**Seismic Walkdown Checklist (SWC)**

Equipment ID No: 1-1501-A7-004-000 Equip. Class<sup>1</sup> 10 - Air Handlers

Equipment Description CTB Cooling Unit & Motor

Location: Bldg. CTB Floor El. 220'±0" Room, Area 1401 Near Column #16

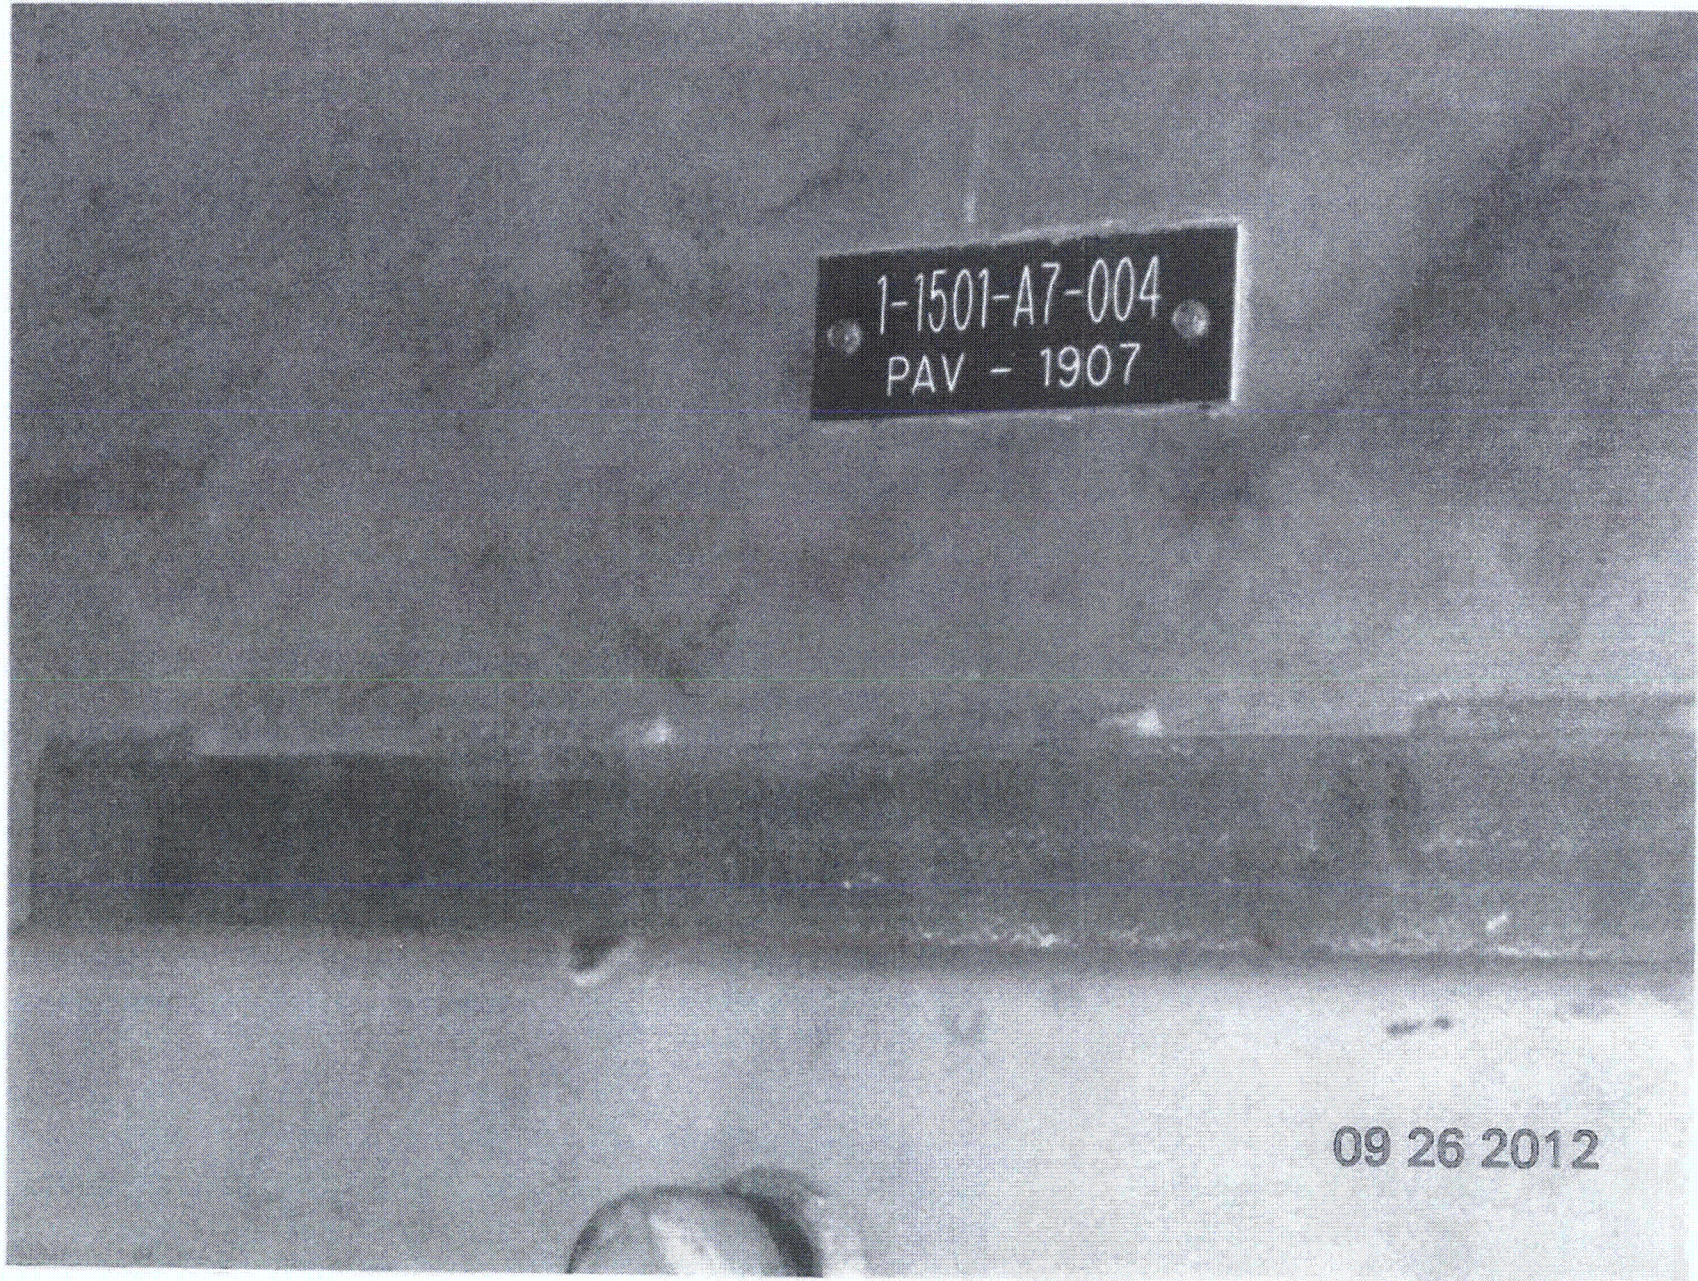
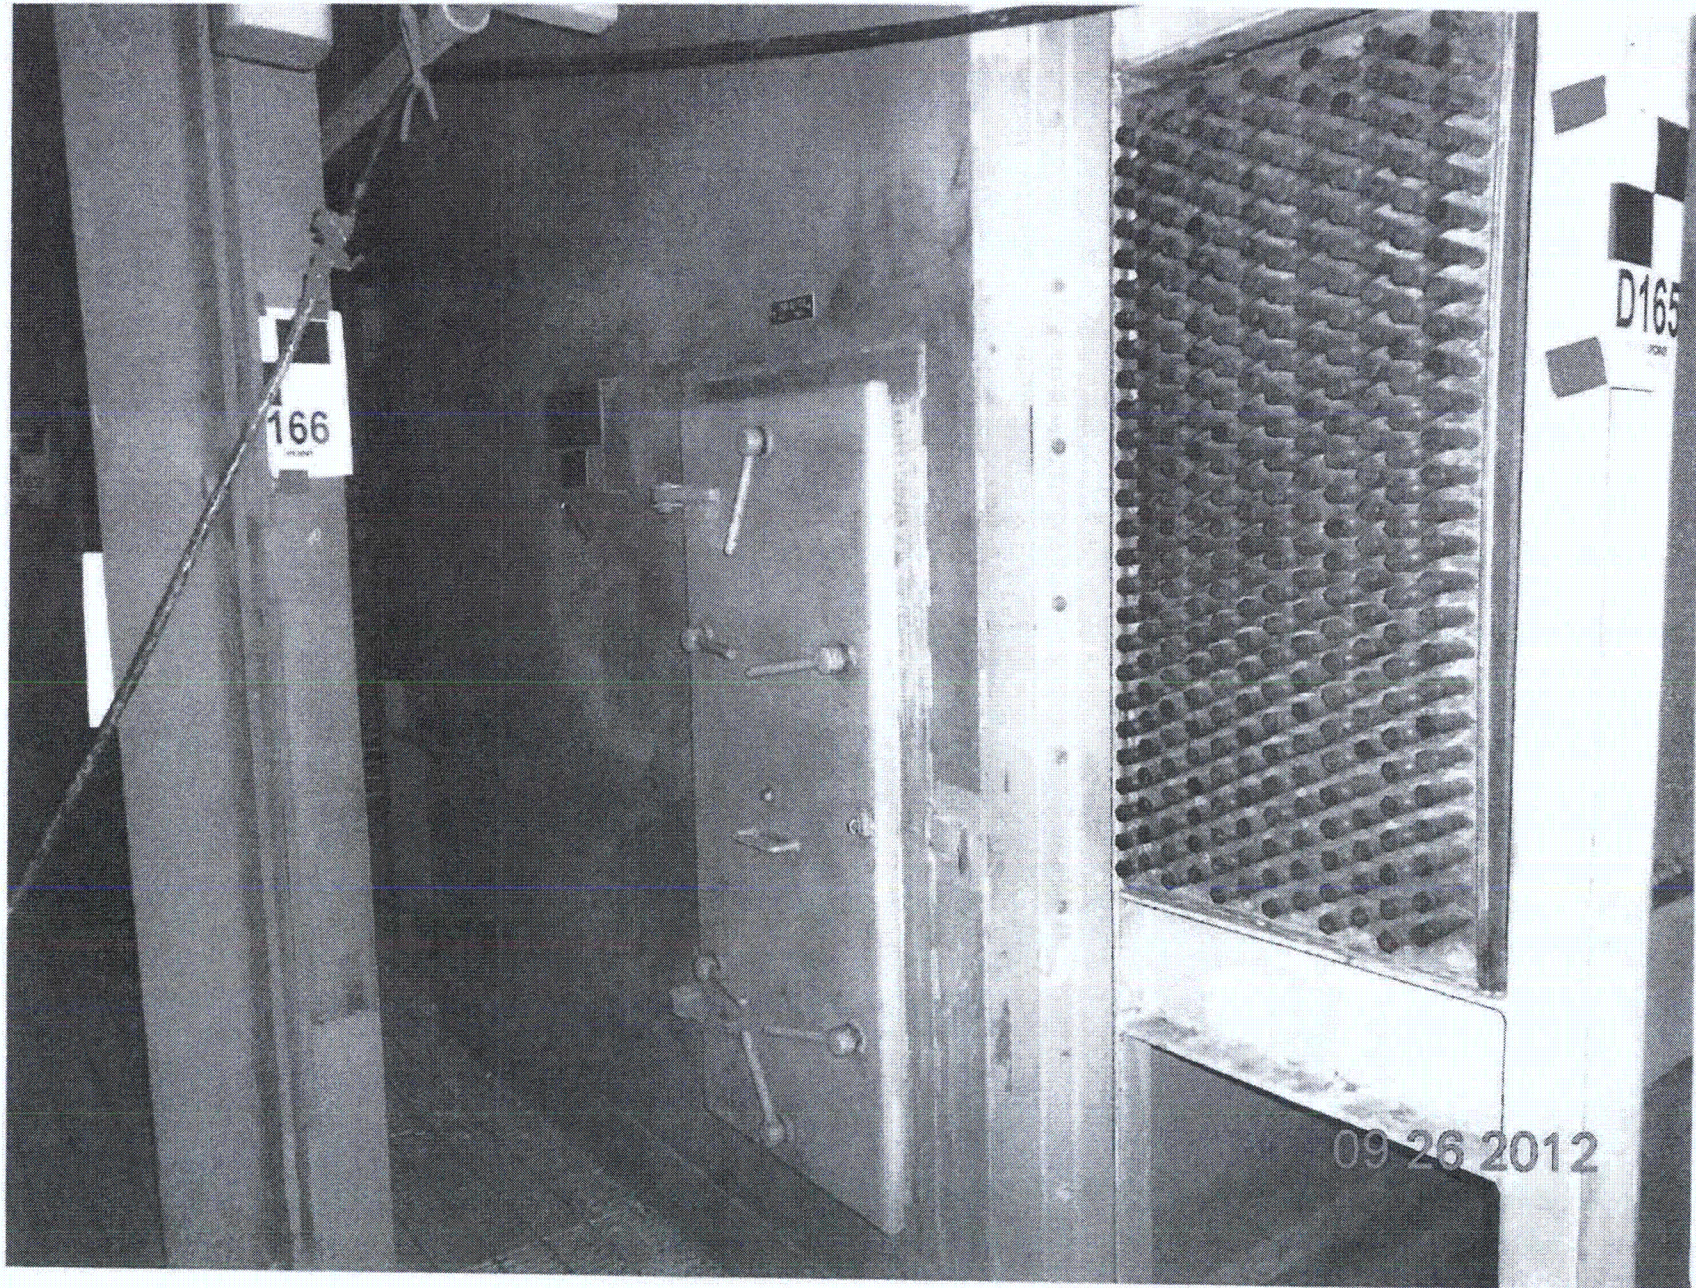
9. Do attached lines have adequate flexibility to avoid damage?  Y  N  U  N/A  
*Mild oxidation found on u-bolt pipe support was judged to be acceptable.*

*One bolt on the upper flange of the fan was skew however the bolt head and nut were tight against the flange. Also, two screws which attach the grating cover of the fan were missing. These bolting conditions were judged to be acceptable based on the relatively low structural demand on*

**Comments** (Additional pages may be added as necessary) *The bolts and condition of the remaining bolts.*

Equipment ID No. 1-HV-0780 Equip. Class: 7 - Pneumatic-Operated Valves

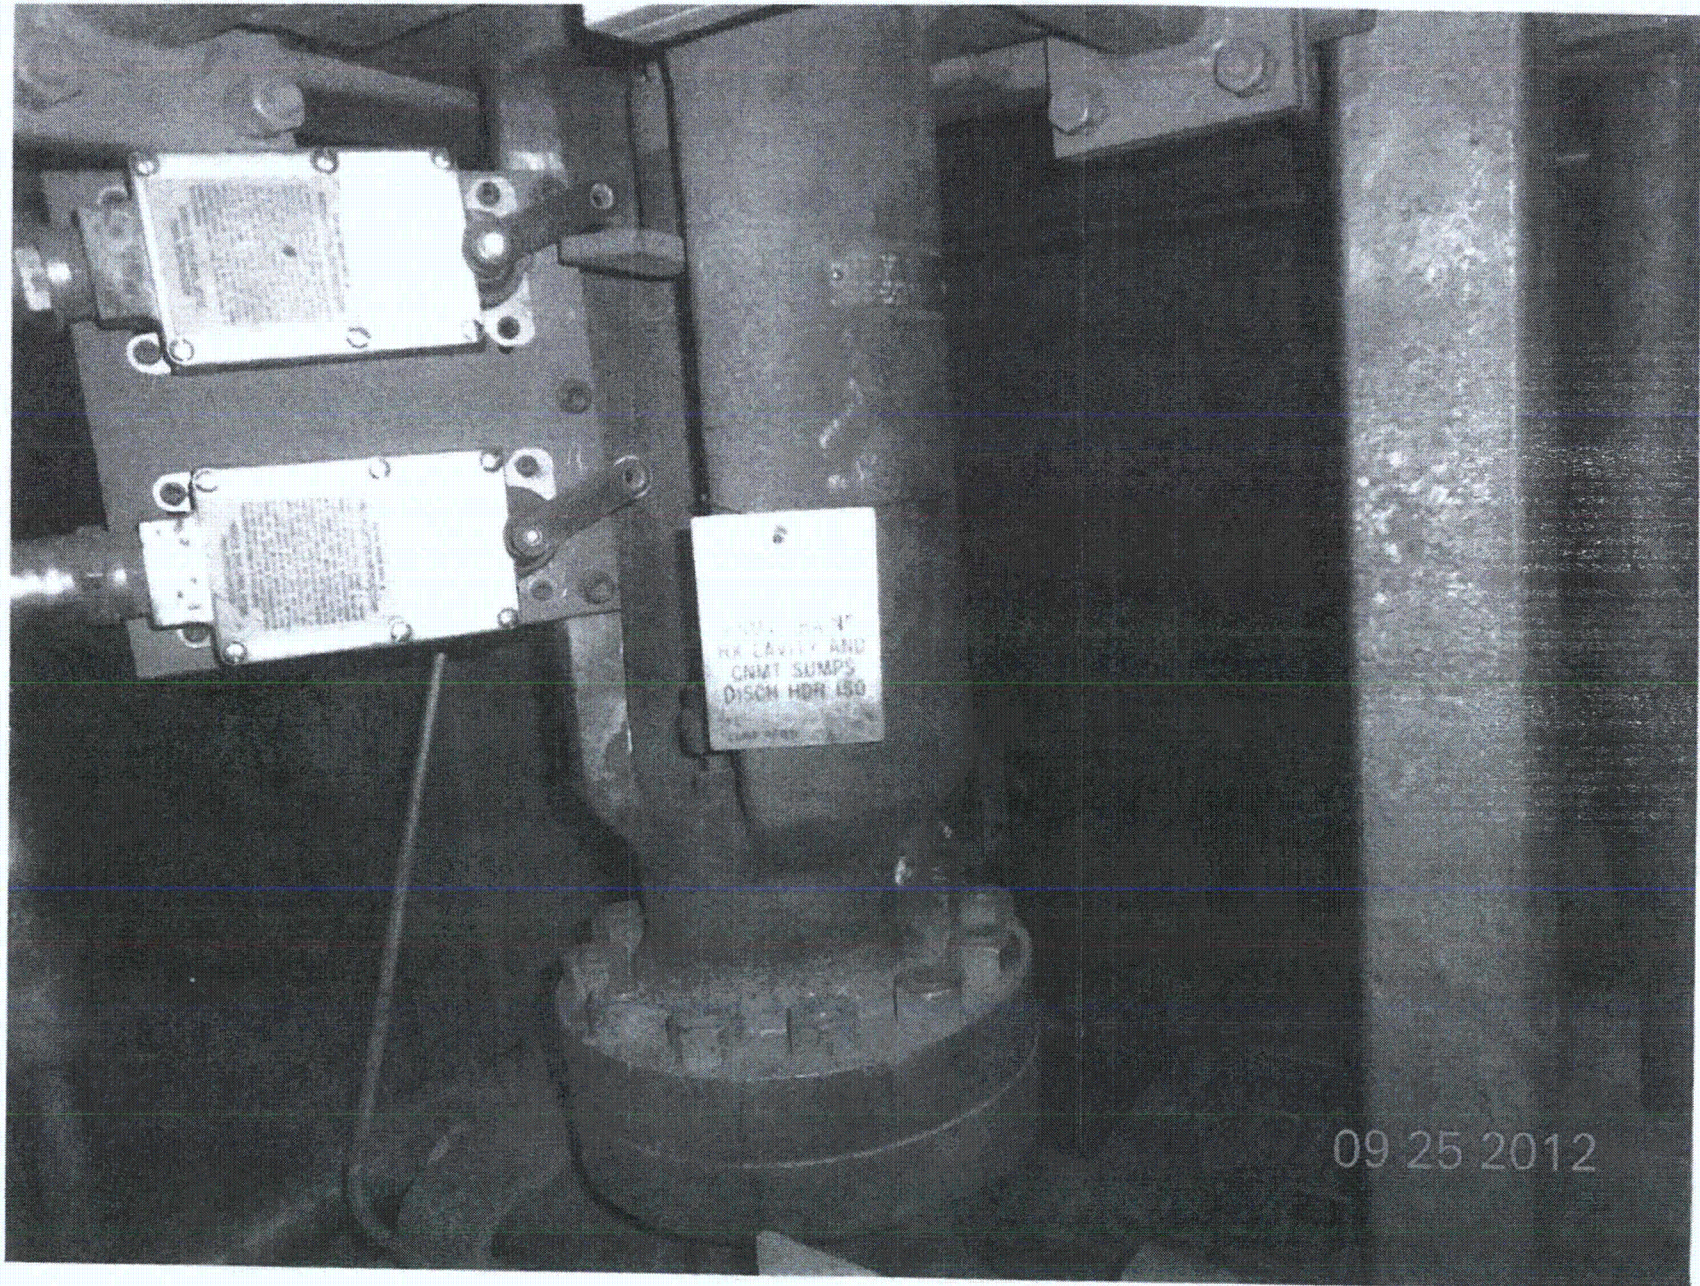
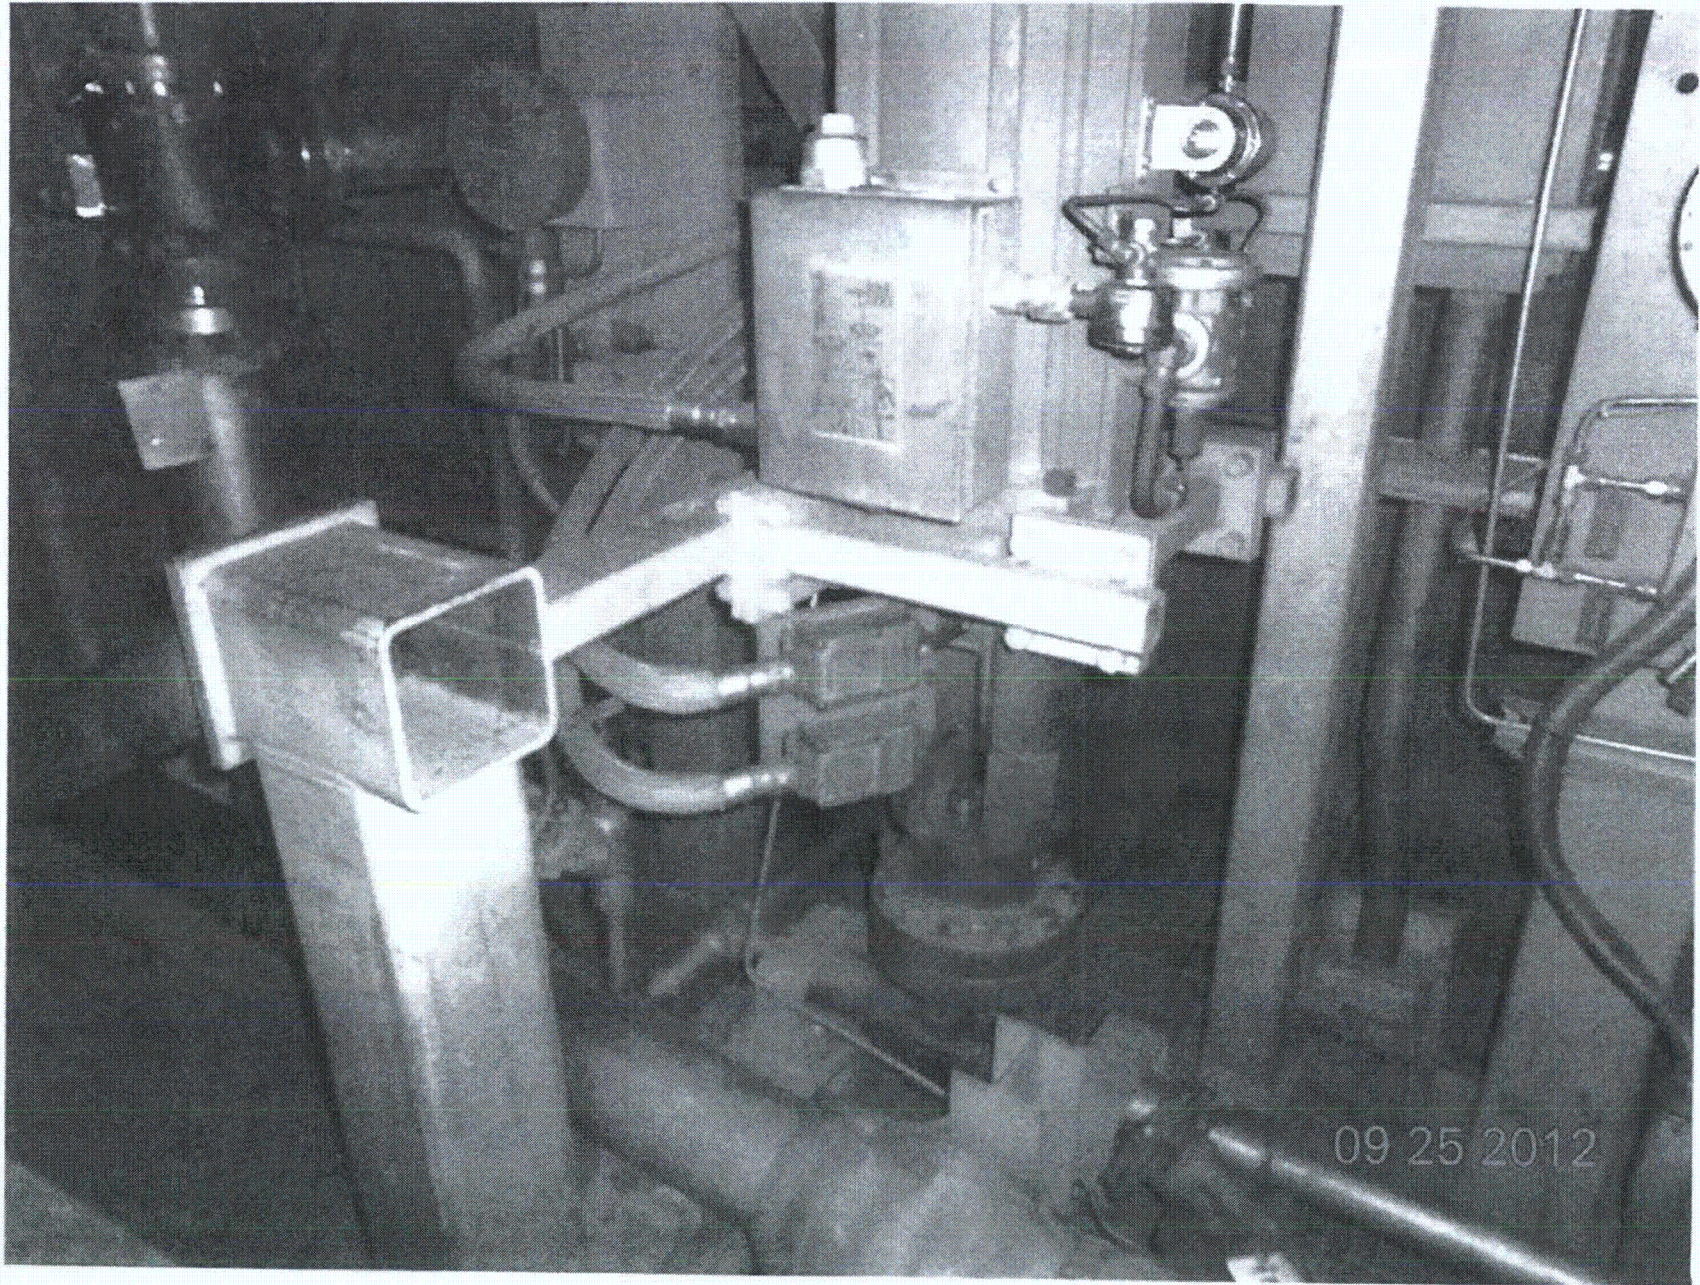
2. Is the anchorage free of bent, broken, missing or loose hardware?  Y  N  U  N/A  
*Inspected horizontal rigid frame which acts as a seismic restraint for the valve.*

*Near by ext sign W.S. 9/25/12 sign has a loose cover. The cover is not a seismic concern to the valve or other components in the area due to the relatively small mass of the cover. RSP. CR 540127*

*Scaffolding installed near the valve was adequately restrained for seismic loads.*

Equipment ID No. 1-HV-1974 Equip. Class<sup>1</sup> 8 - Motor-Operated and Solenoid-Operated Valves

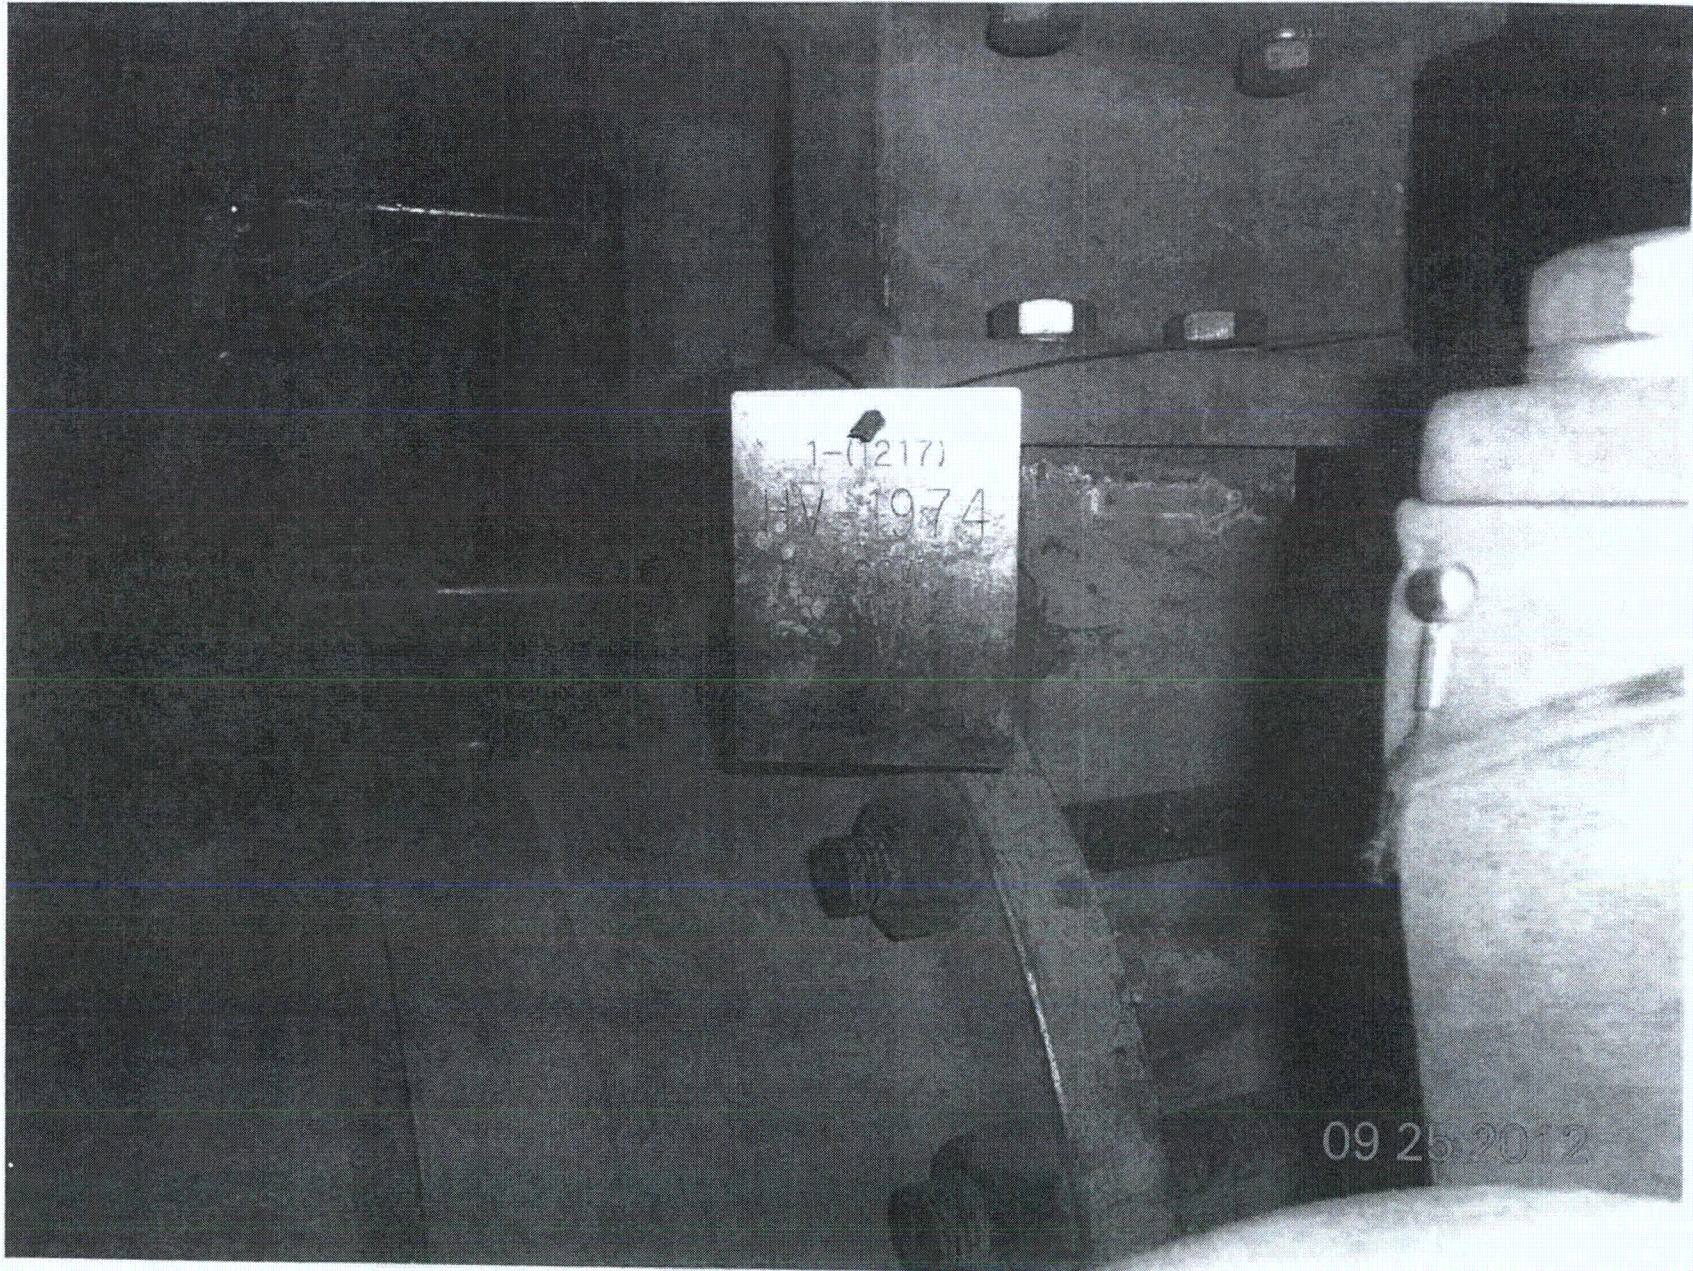
*Only structural steel and grating above - satisfactory installation.*

*Flexible conduits attached*

*Scaffolding around and near component is seismically installed - well supported.*
